Proposal #15: 2190-10-70
C Wauwatosa W Wisconsin Ave
Bridge Over Honey Creek P-40-776
Local Street
Milwaukee County

This is Addendum No. 01, which provides for the following:

ADDENDUM NO. 01
2190-10-70, 2190-10-71
February 6, 2025

PROPOSED TYPICAL SECTION HONEY CREEK
STA 137+50 - STA 138+75

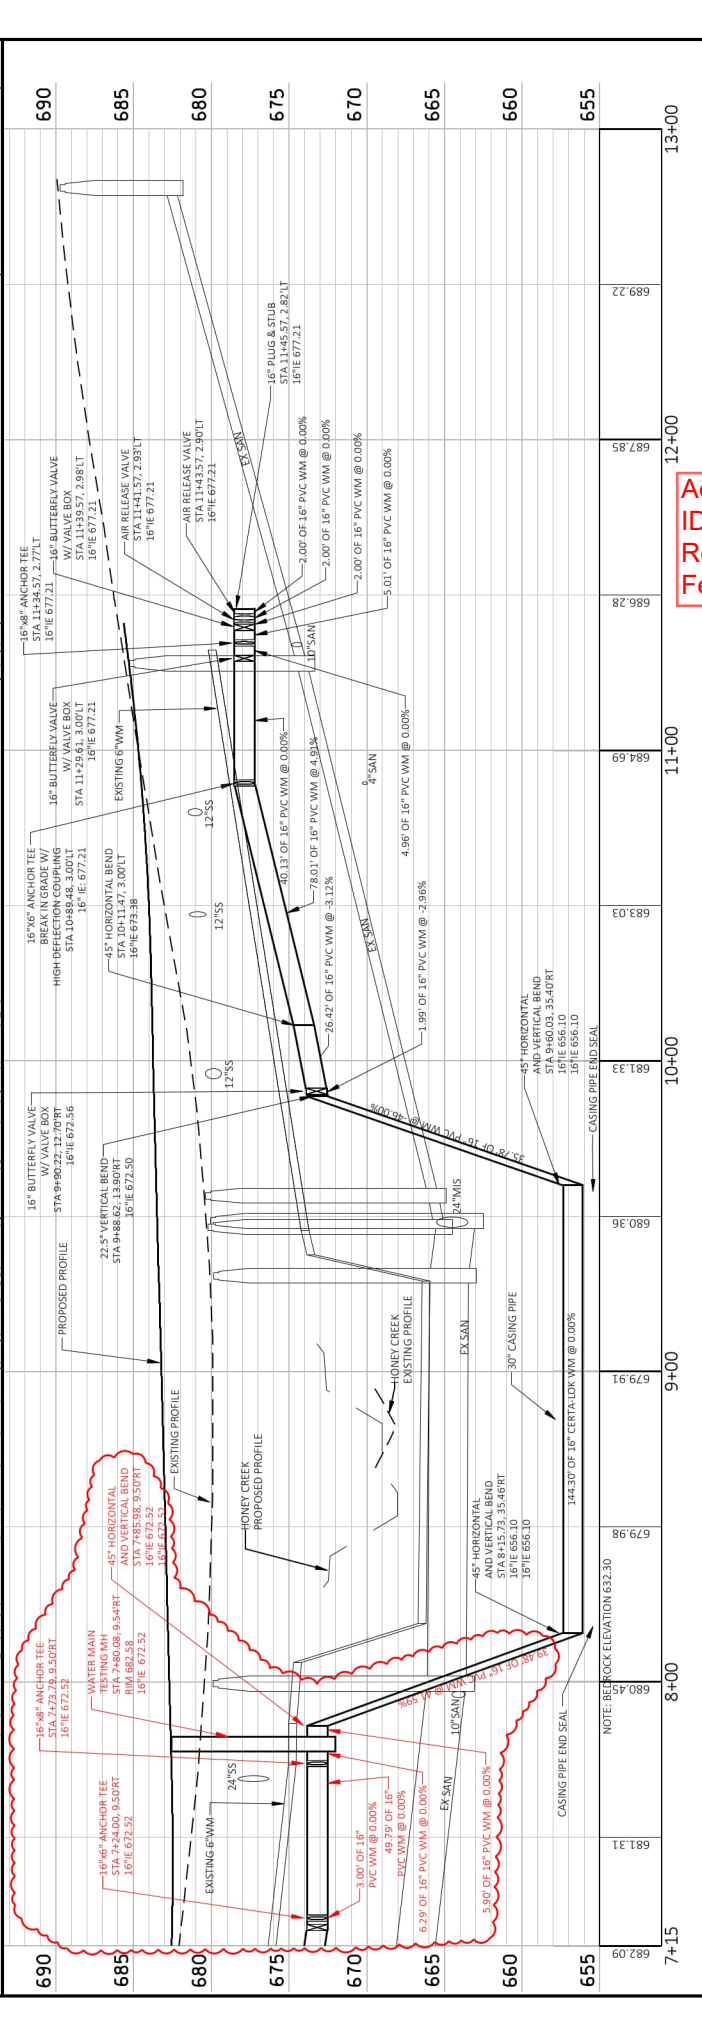
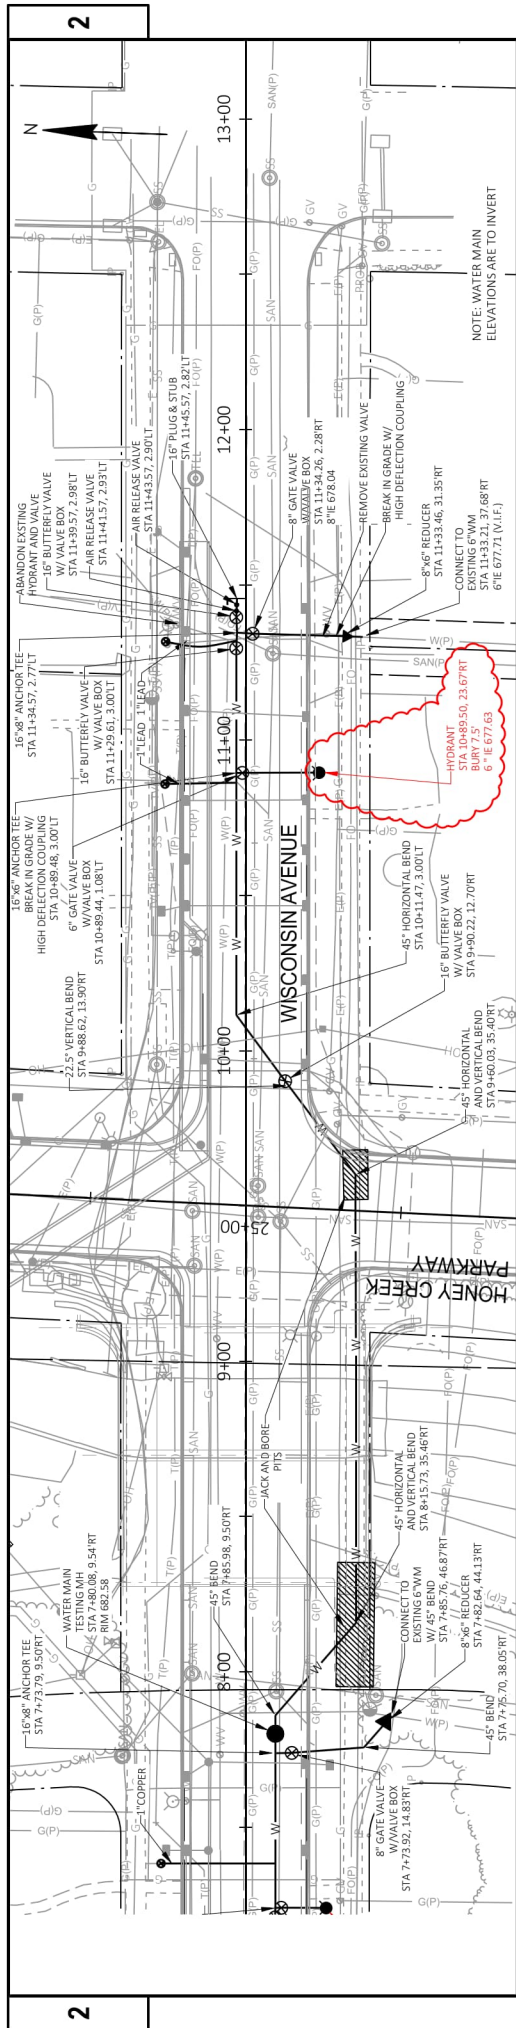
Revised Plan Sheets	
Plan Sheet	Plan Sheet Title (brief description of changes to sheet)
11	Proposed Typical Sections (Updated stream typical section dimension)
46	Contour Plan (Updated stream grading)
59	Watermain Plan and Profile (Updated watermain elevations)
60	Watermain Plan and Profile (Updated watermain elevations)
73	Traffic Signal Plan (Added meter breaker pedestal location and associated conduit/pull boxes)
76	Traffic Signal Plan (Added meter breaker pedestal location and associated conduit/pull boxes)
95	Miscellaneous Quantities (Updated stream earthwork)
104	Miscellaneous Quantities (Updated Conduit, Pull Box, and Concrete Base tables)
120	Plan and Profile: Honey Creek Stream Realignment (Updated stream linework)
121	Plan and Profile: Honey Creek Paths (Added light pole callout)
230	Earthwork Data (Updated stream earthwork)
252	Cross Sections: Honey Creek Stream Realignment (Updated stream grading)

Addendum No. 01
ID 2190-10-70/71
Revised Sheet 253
February 6, 2025

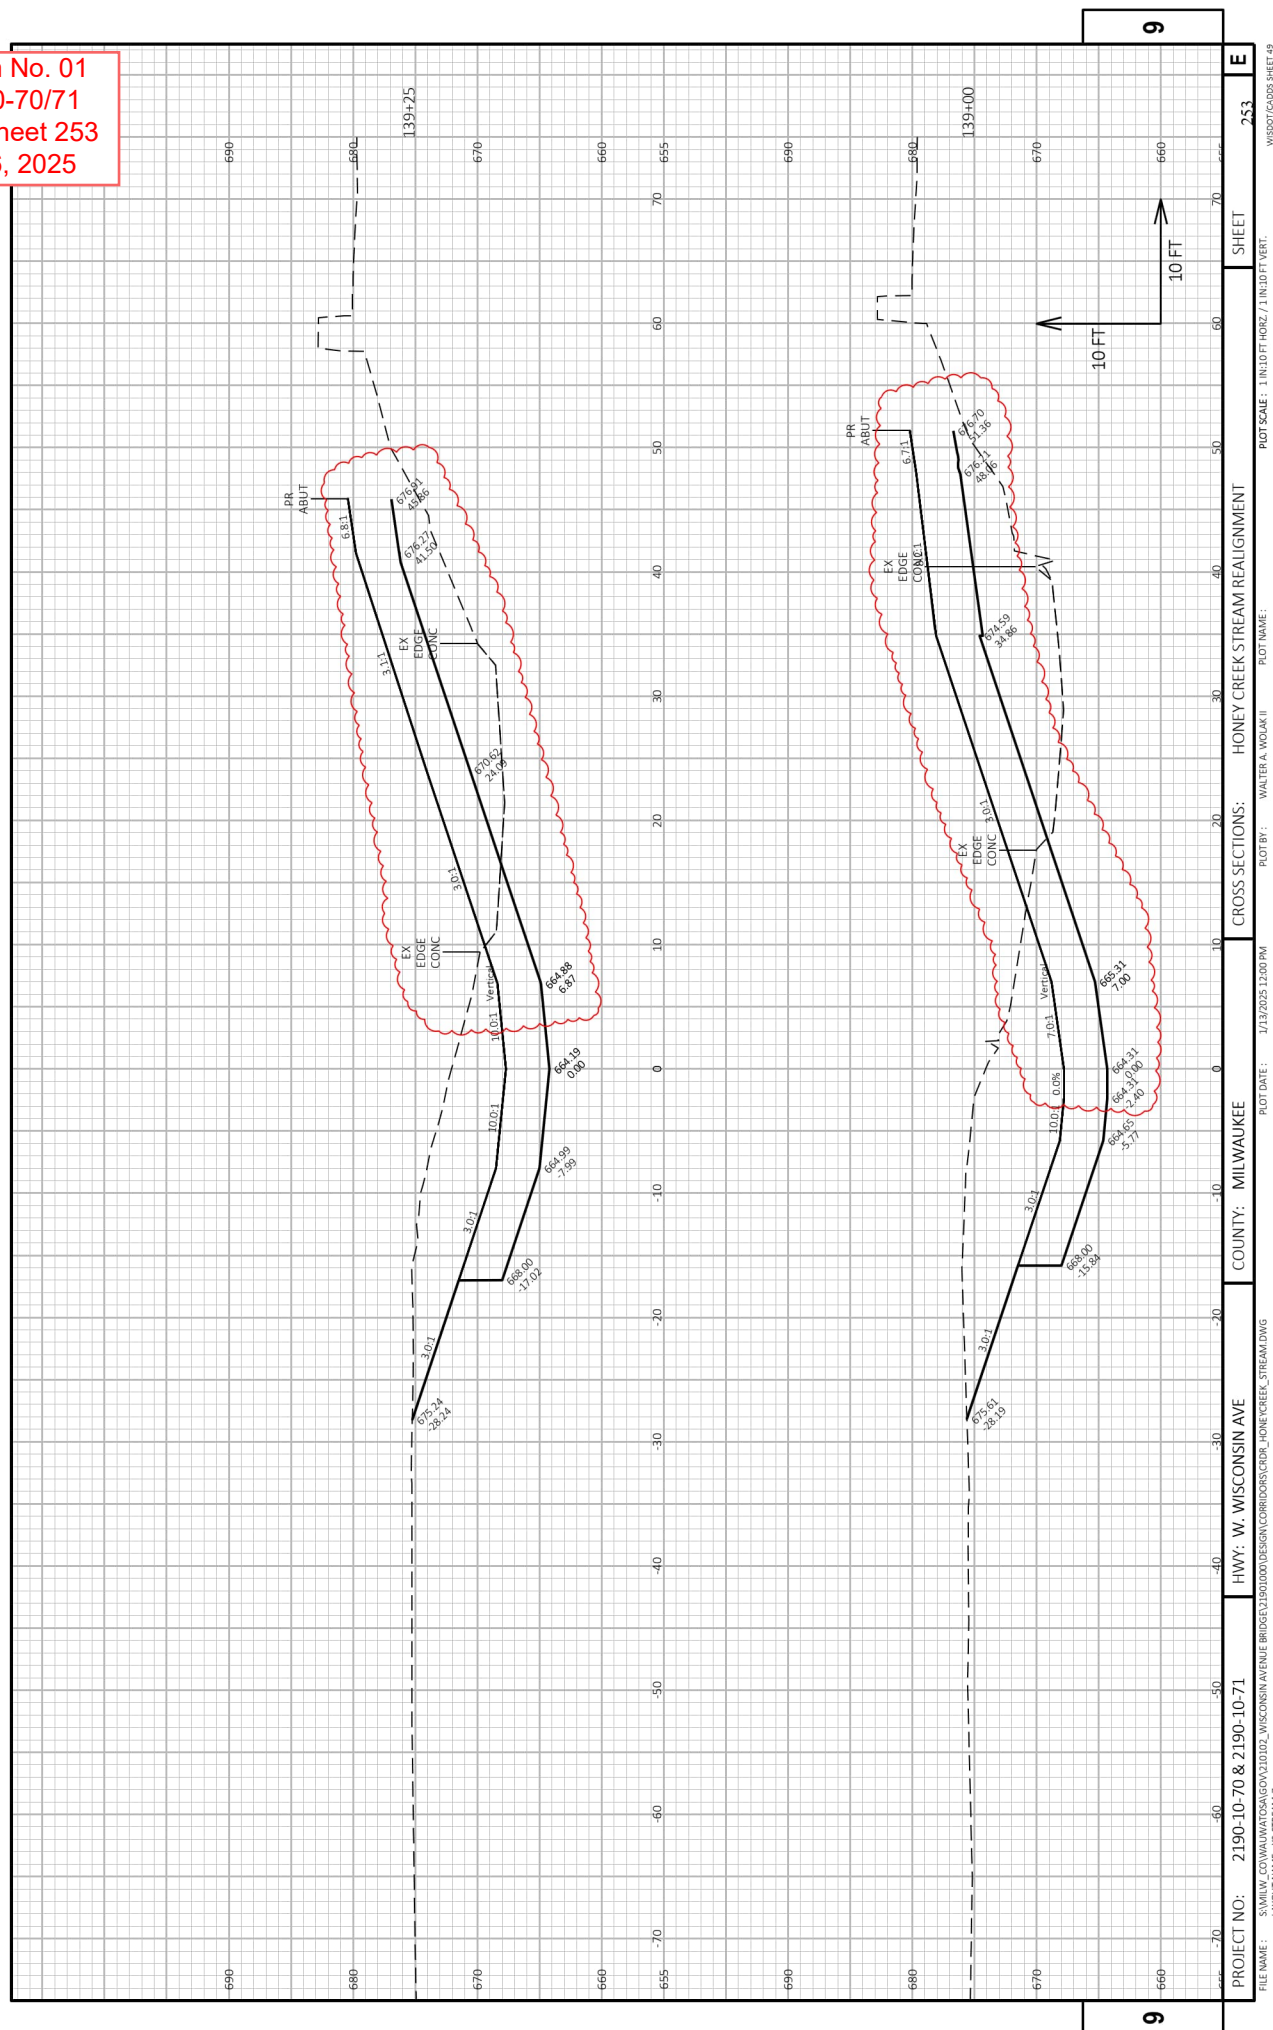
253	Cross Sections: Honey Creek Stream Realignment (Updated stream grading)
